# **8XC196NT SPECIFICATION UPDATE**

Order Number 272865-002

The 8XC196NT may contain design defects or errors known as errata. Characterized errata that may cause the 8XC196NT's behavior to deviate from published specifications are documented in this specification update.

Figure 1. ICC, IDLE versus Frequency

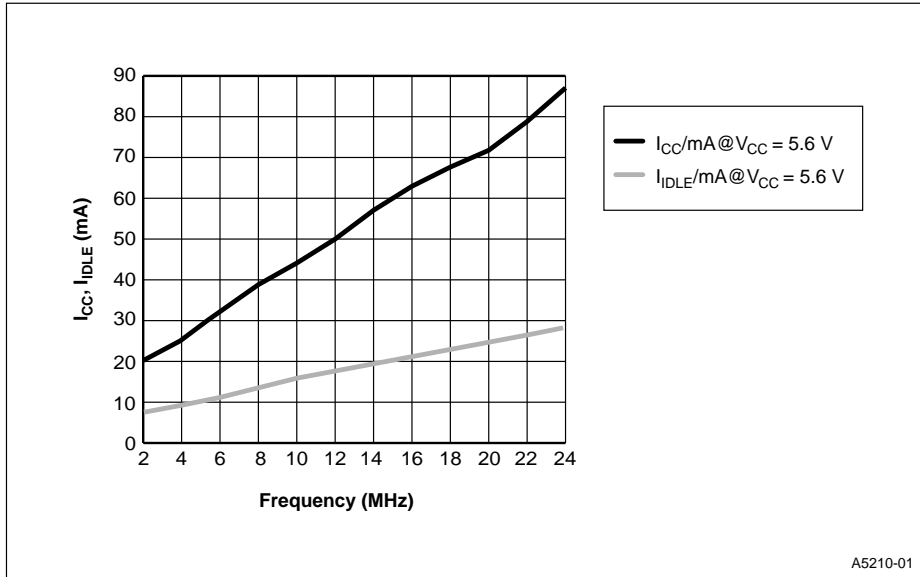
### 001. *ICC, IDLE versus Frequency*

**ITEM:** The following graphic illustrating ICC and IDLE versus Frequency will be added to the next revision (-005) of the 8XC196NT CHMOS Microcontroller datasheet.
